UTILITY PATENT APPLICATION TRANSMITTAL

Attorney Docket No.	DYN005
First Inventor	Mark Zehfuss
Title	SEAT ATTACHMENT FOR A STROLLER
Express Mail Label No.

UPPABABY ET AL. EX. 1014

Fig. 7

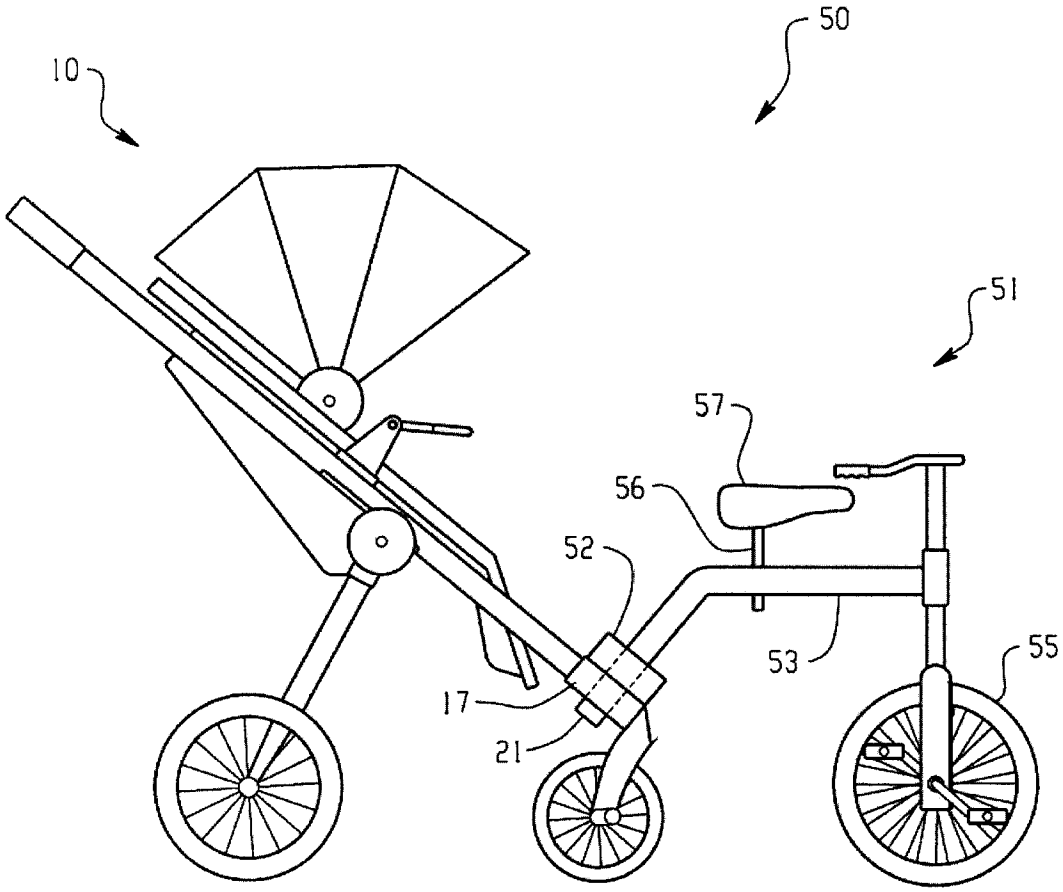
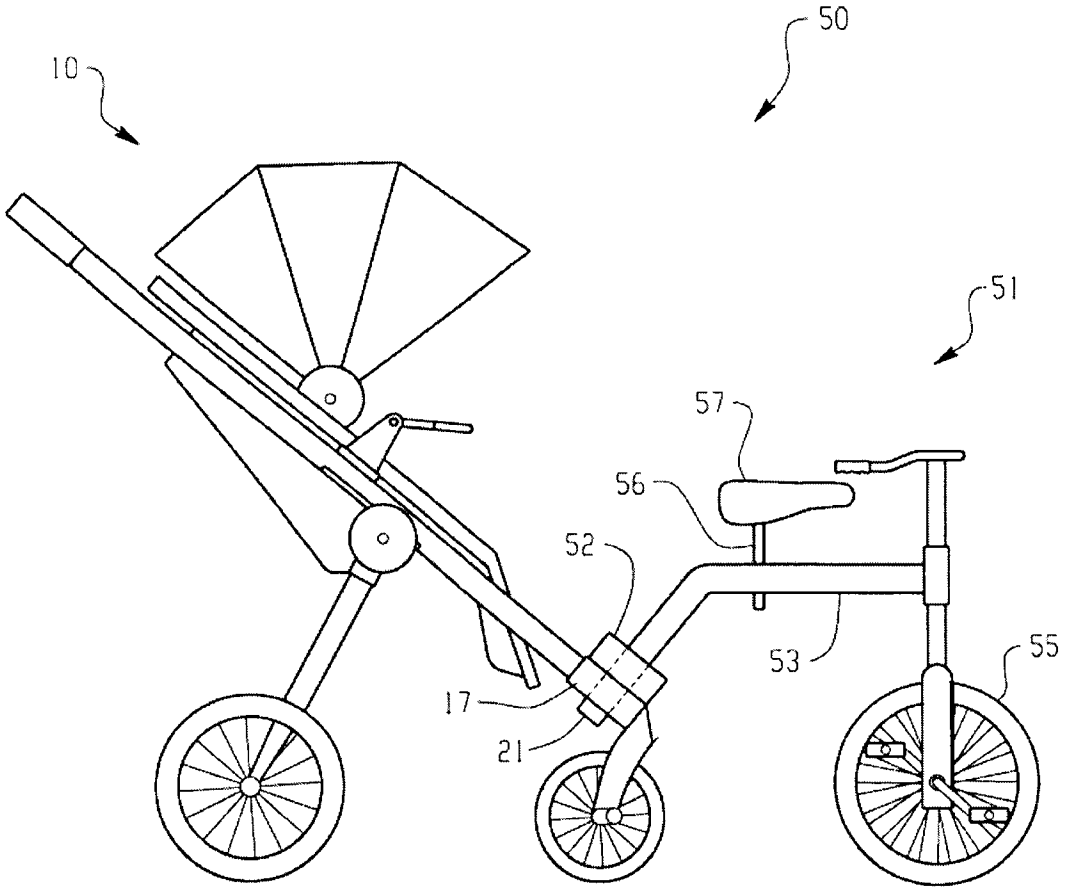
9. The disclosure is objected to because of the following informalities: The 'Description' section of the specification fails to describe or even mention Figure 7. The 'Description' section of the specification also fails to adequately describe Figures 9A-9F. Appropriate correction is required.

6. The drawings are objected to as failing to comply with 37 CFR 1.84(p)(4) because no reference characters have been used to designate the parts in Figure 7. Applicant has added new paragraph [0043] to the Specification, but failed to amend Figure 7 which pertains to this paragraph. Corrected drawing sheets in compliance with 37 CFR 1.121(d) are required in reply to the Office action to avoid abandonment of the

The description has been amended to describe Figure 7 and Figures 9A through 9F.

Fig. 8

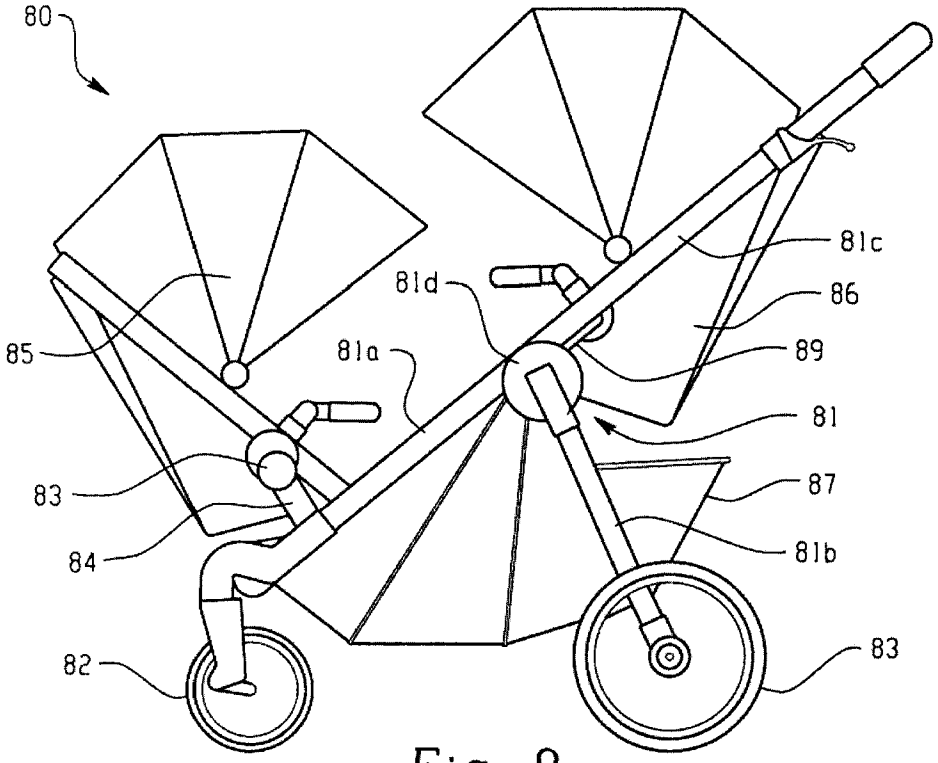
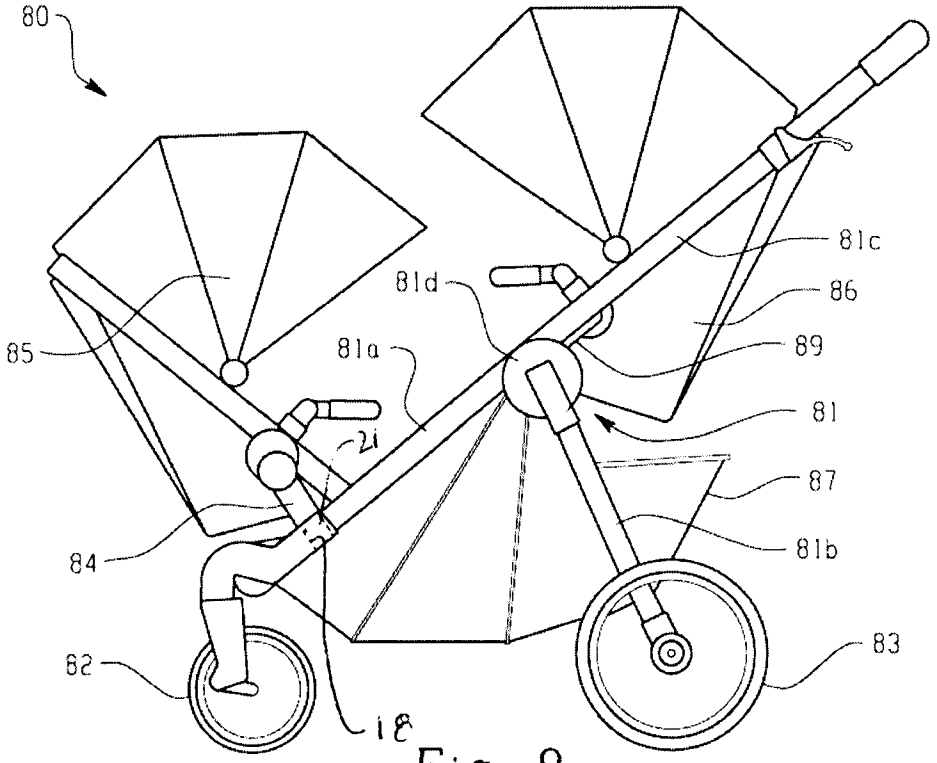
7. The drawings are objected to as failing to comply with 37 CFR 1.84(p)(4) because reference character “83” has been used to designate both “rear wheel” and another unnamed part in Figure 8. Corrected drawing sheets in compliance with 37 CFR 1.121(d) are required in reply to the Office action to avoid abandonment of the application. Any amended replacement drawing sheet should include all of the figures appearing on the immediate prior version of the sheet, even if only one figure is being amended. Each drawing sheet submitted after the filing date of an application must be labeled in the top margin as either “Replacement Sheet” or “New Sheet” pursuant to 37 CFR 1.121(d). If the changes are not accepted by the examiner, the applicant will be notified and informed of any required corrective action in the next Office action. The objection to the drawings will not be held in abeyance.

The reference character "83" designated the unnamed part has been deleted from Figure 8;

4. The drawing objection with regard to reference character "83" in Figure 8, is withdrawn in light of the amendments.

Fig. 10

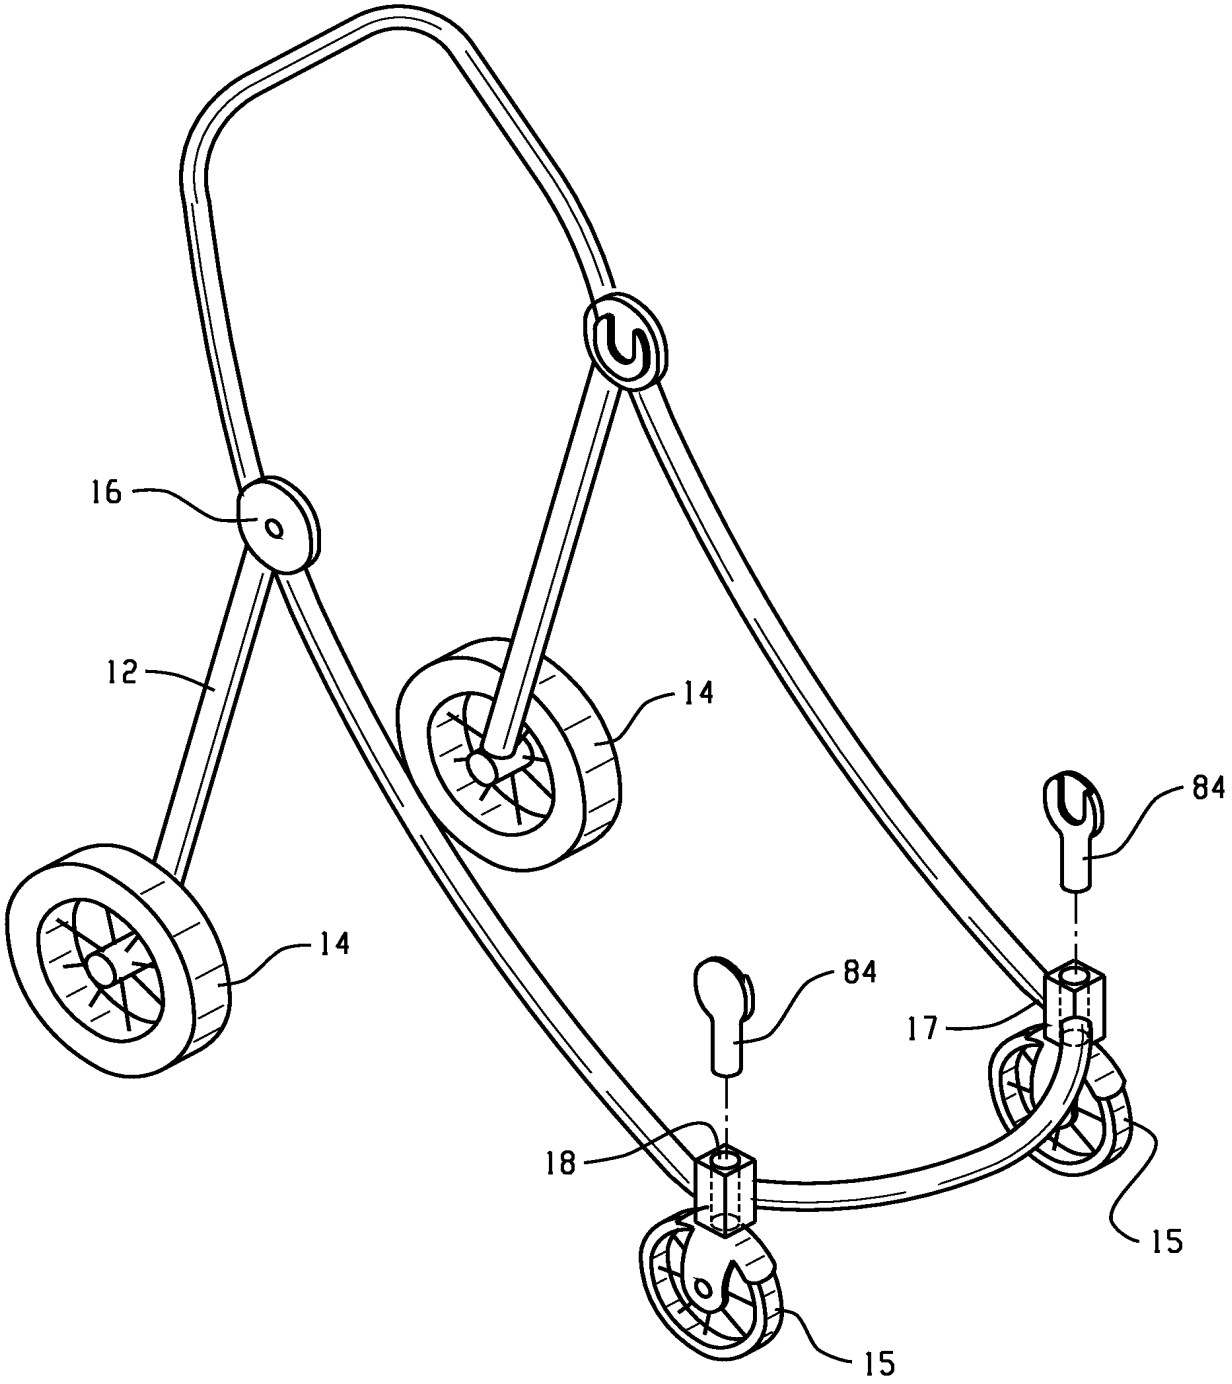
7. New corrected drawings in compliance with 37 CFR 1.121(d) are required in this application because it is not clear how the seat attachment and stroller mate especially from a frontal view of the stroller. It is not clear why Applicant has only provided side views of the various strollers, but Applicant is encouraged to provide additional views of the stroller and seat attachment which clearly illustrate how the attachment device mates with the stroller. New Figures 1A and 2A fail to illustrate how two separate attachment frame members/portions (as claimed) mate to the stroller frame. Applicant is advised to employ the services of a competent patent draftsperson outside the Office, as the U.S. Patent and Trademark Office no longer prepares new drawings. The corrected drawings are required in reply to the Office action to avoid abandonment of the application. The requirement for corrected drawings will not be held in abeyance.

Applicants have added new drawings, FIG. 10 and FIG. 11, as requested by the examiner to show an additional view of the invention. The drawings do not include new matter but clearly show the stroller in a perspective view, the two separate attachment frame members that each may be removably connected to the stroller adjacent to each front wheel and the stroller seat that may be removably and reversibly connected between the two separate frame attachment members. The separate seat attachment members as shown in FIG. 10 and FIG. 11 are discussed in paragraph [0015] as well as elsewhere in the specification, for example.
